A Review of the Millstone 3 Probabilistic Safety Study

A. A. Garcia, D. L. Bernreuter, T. E. McKone, P. D. Smith (LLNL), P. J. Amico (Applied Risk Technology Corporation), J. W. Reed, M. W. McCann, Jr. (Jack R. Benjamin & Associates, Inc.), P. R. Davis and G. Apostolakis (Consultants)

Prepared for
U.S. Nuclear Regulatory Commission

Manuscript Completed: December 1985
Date Published: April 1986

Fig. 3.2-10 Spurious safety injection event tree.

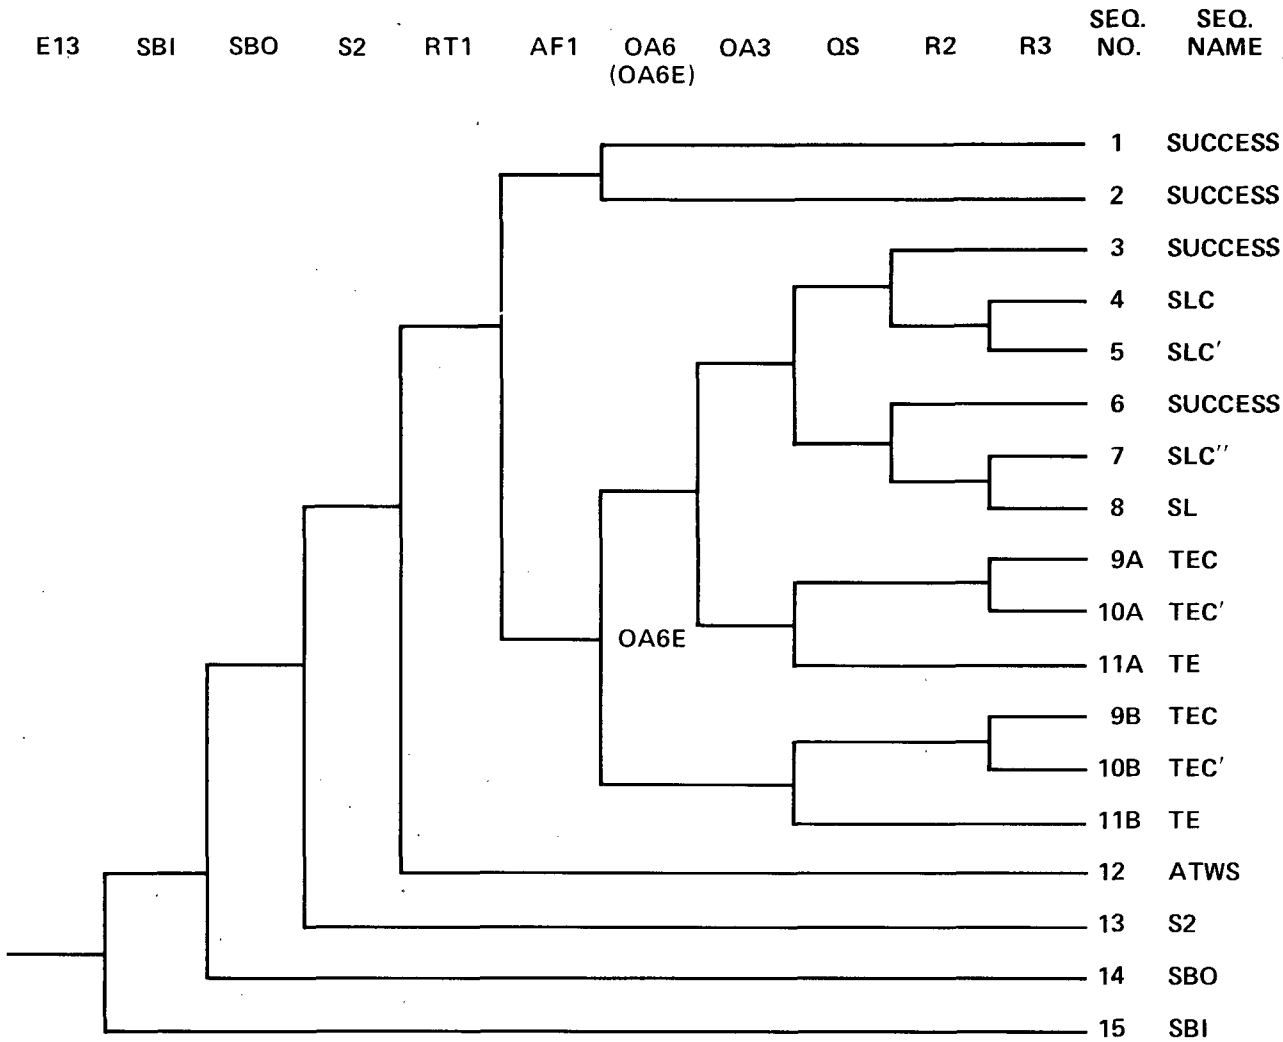
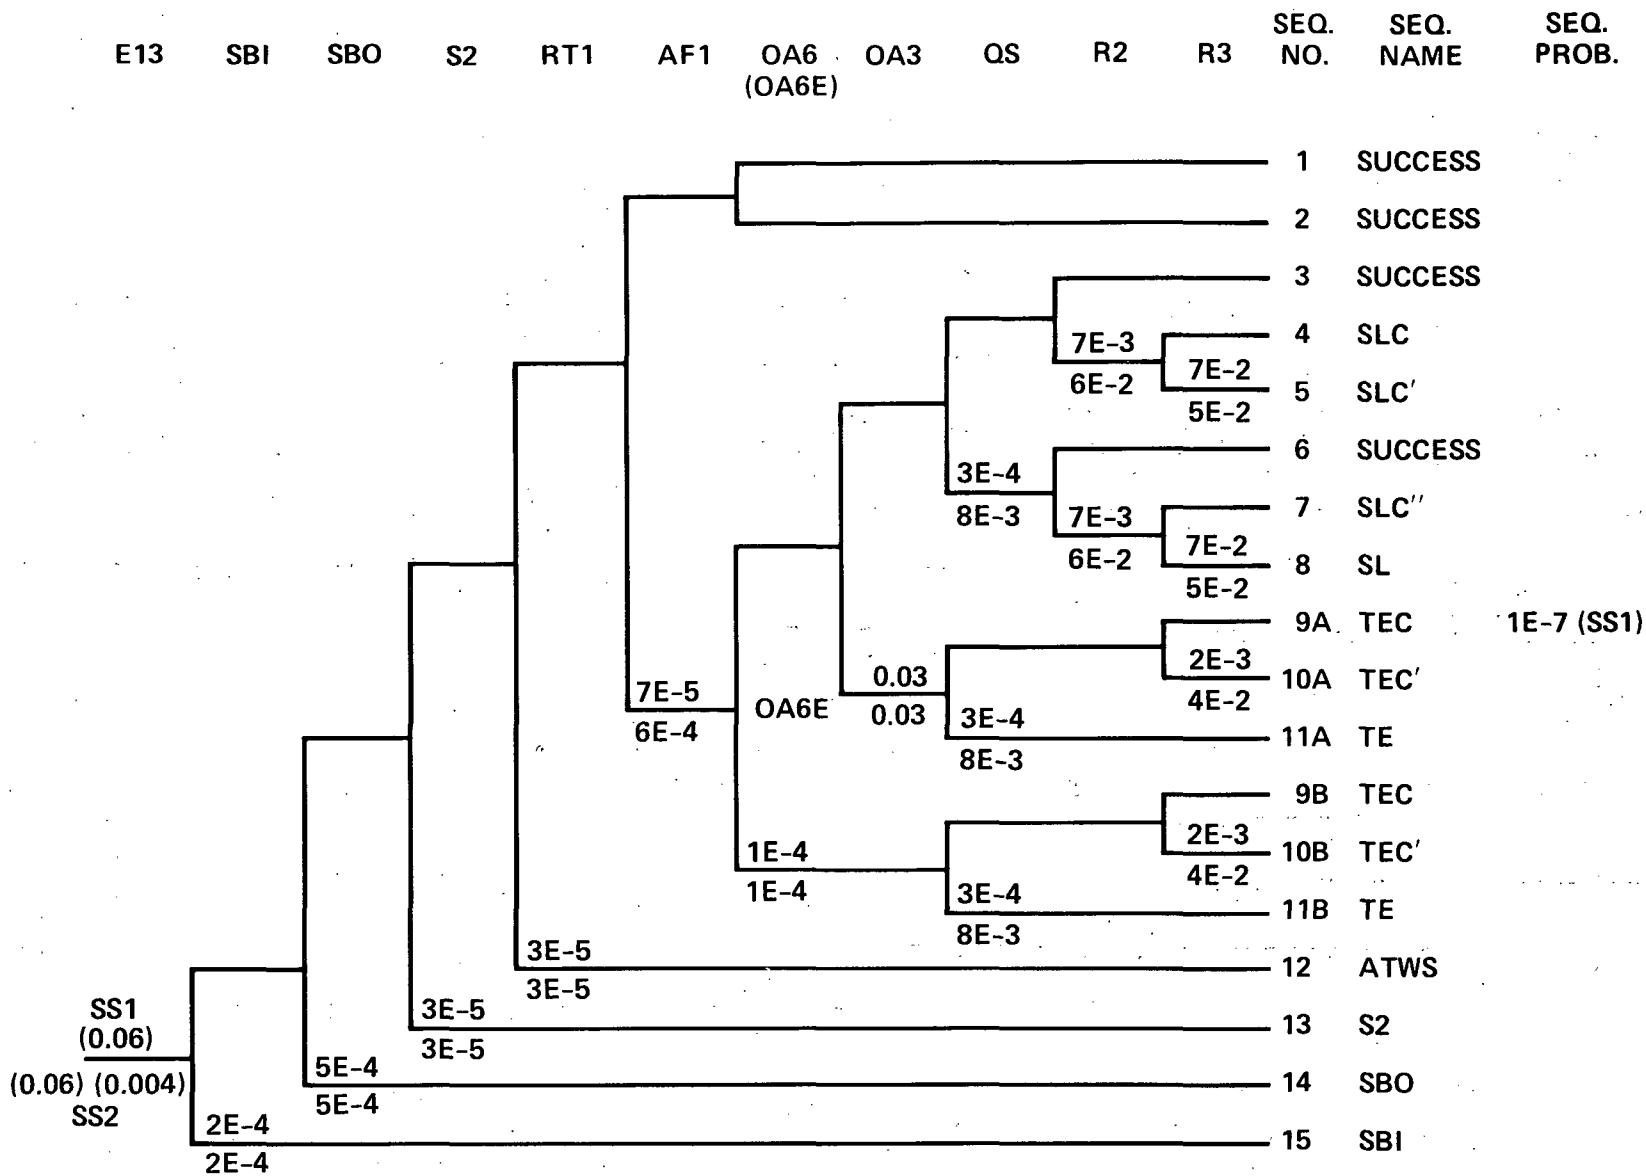
The use of operator action OA-7, primary bleed and feed, is incorrect on this tree. While bleed and feed cooling is valid for this event, OA-7 includes the unavailability of HPI in its unavailability value. The initiating event itself implies that HPI is already operating. Further, the other events on the tree, such as OA-6, assume that HPI is already operating. Thus, the proper event to use on the tree would be operator action OA-3, primary bleed. This would serve to establish bleed and feed cooling. The modified event tree is shown in Fig. 3.2-10.

Fig. 3.9-2 MP 3 simplified RHR system from S&W drawing no. 12179-EM-112A-1 (4/14/82).

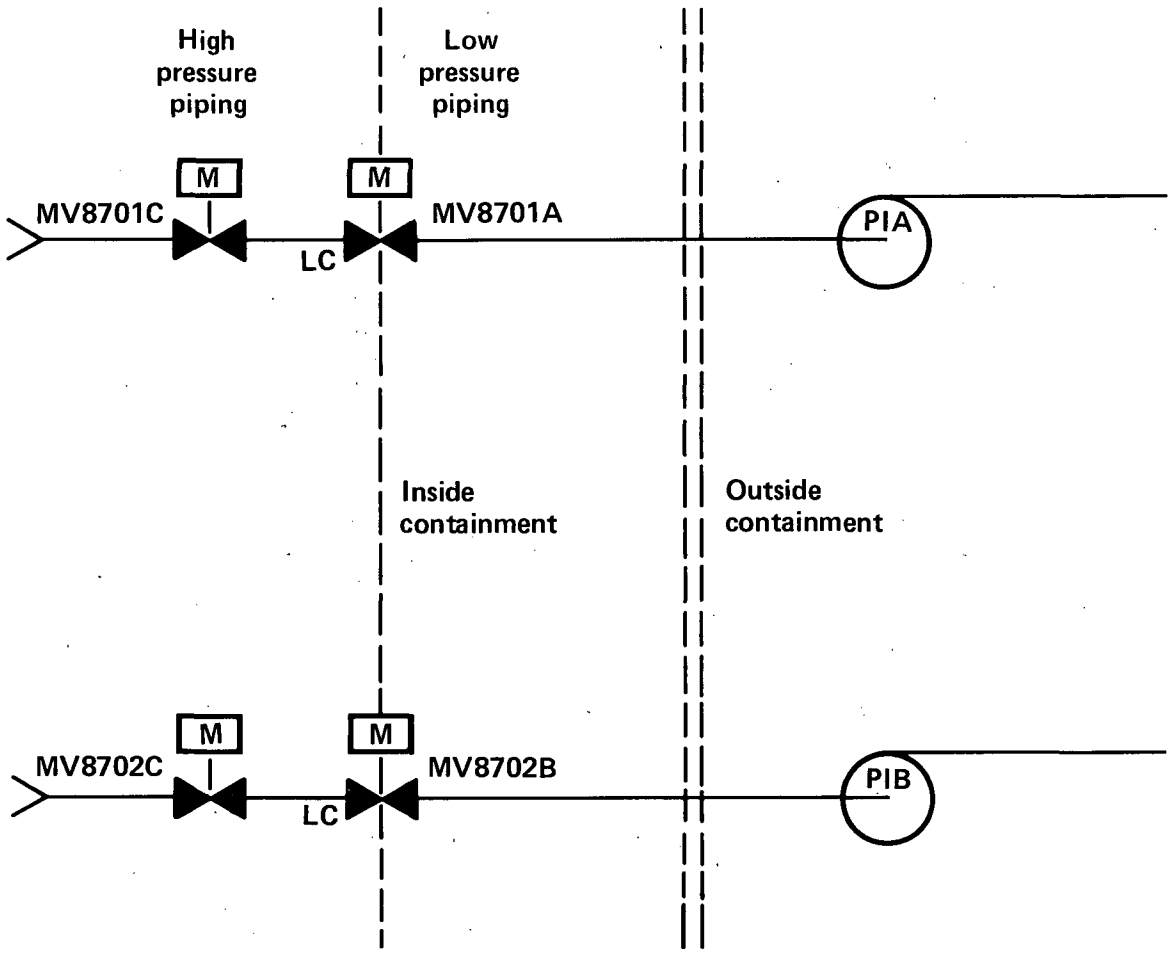
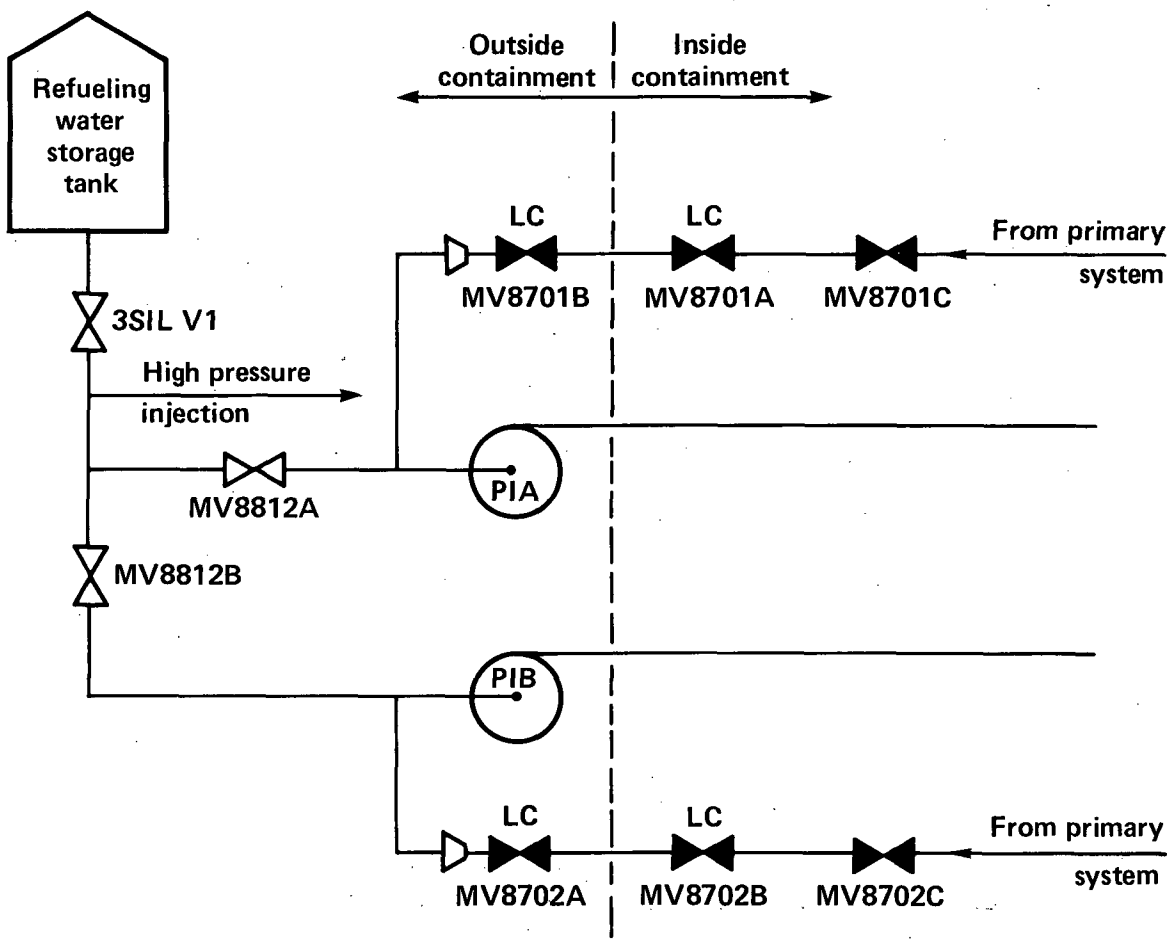
Figure 3.9-2, which is based on P&ID drawing S&W #12179-EM-112A-1, indicates that a third valve (MV8702A and B) exists in both RHR suction lines. Based on other plant designs, it seems likely that the transition from high to low pressure pipe would occur at the location of these valves rather than inside the containment. If this is the case, the probability of the V-sequence accident would be reduced dramatically since a third valve, normally locked closed, would have to fail. (The S&W drawing does not indicate the design pressure transition point.) If low pressure pipe is located between the inside and outside valves (as implied by the PSS assessment), then there is a possibility of a rupture outside containment. However, depending on relative pipe segment lengths inside and outside the containment, the probability of an outside rupture would be reduced over the PSS value.

Fig. A-3 Comparison of hazard curves generated by SEP experts, D&M, and USGS approaches.

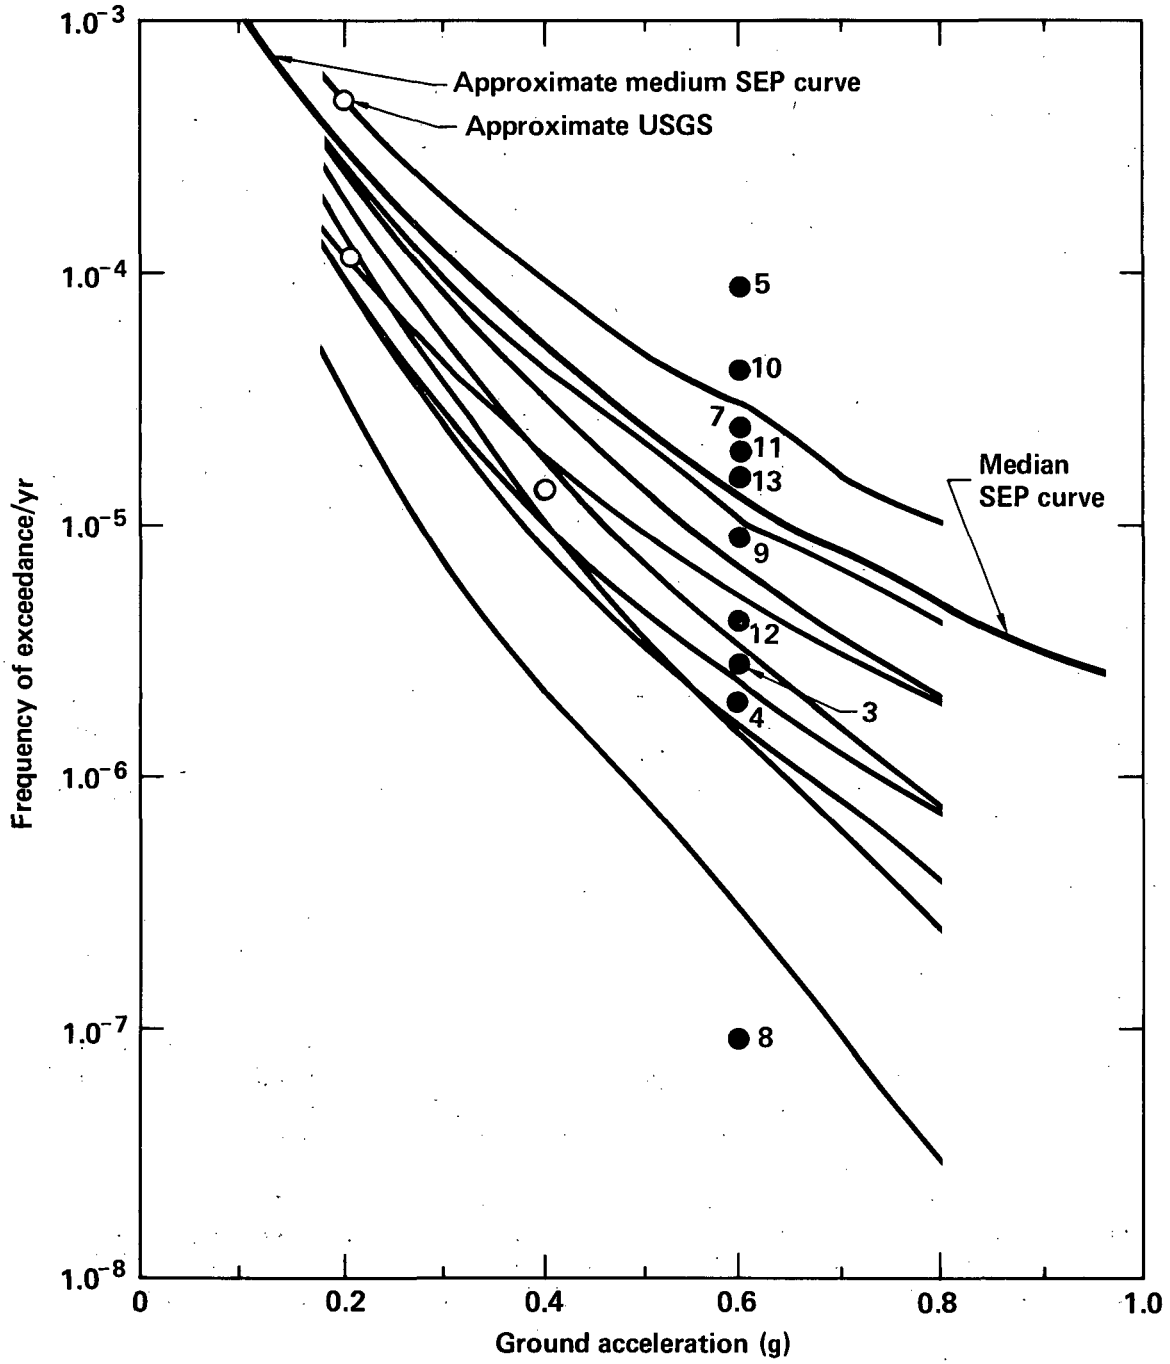
Figure A-3 shows the median curve from Fig. A-2 plotted on PSS Fig. 1.2.1-1. Also shown is the spread of our curves at 0.6g from Fig. A-2. It is seen from this figure that the D&M results are within the spread of the SEP results, but on the low side. It is not possible to determine exactly where the D&M median curve lies relative to the SEP and USGS results because the D&M curves are not equally weighted and the probabilities are not given on the various hazard curves. The D&M median appears to be about a factor of 5 low compared to the SEP median. A reasonably complete uncertainty analysis would spread out the scatter in the curves even more. However, this increase in uncertainty in the seismic hazard is considered unlikely to have much effect on the median curve. But it could have significant effect on the risk as it is generally found in such analyses that an increase in uncertainty increases the risk.

FIGURE 2-1. MILLSTONE RESPONSE SPECTRA FOR 10% DAMPING

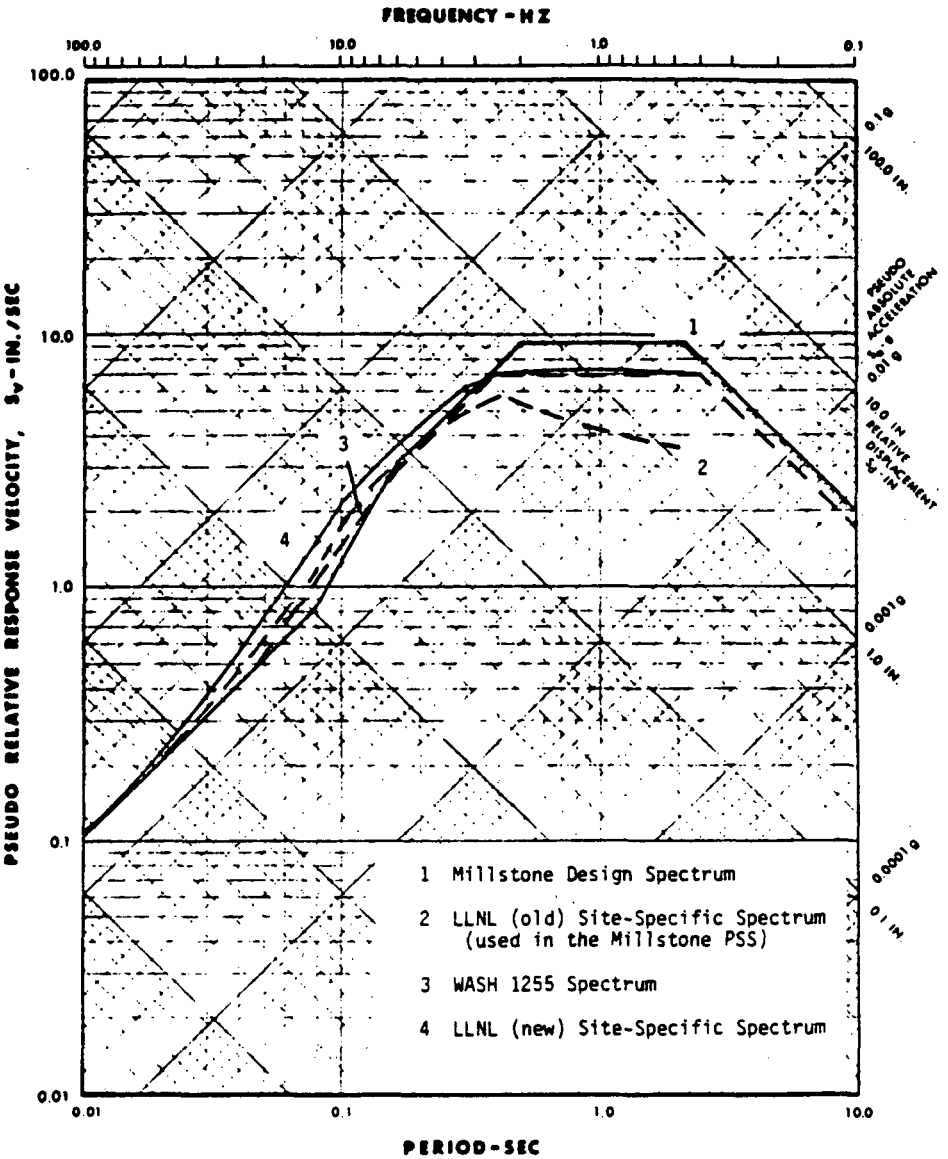
Based on the comparison in Figure 2-1 we find that the magnitude-dependent spectra are generally higher than the design spectra for frequencies greater than 5 Hz. Among these, the most recent spectra developed by LLNL has the highest spectral level. At frequencies less than 5 Hz, the design spectrum exceeds the site-specific spectrum, with the greatest variations occurring at frequencies less than 2 Hz.

4. The NRC should determine if the site-specific spectrum used in the fragility analysis is appropriate. See Table 2-1 and Figure 2-1 for a comparison of different response spectra.
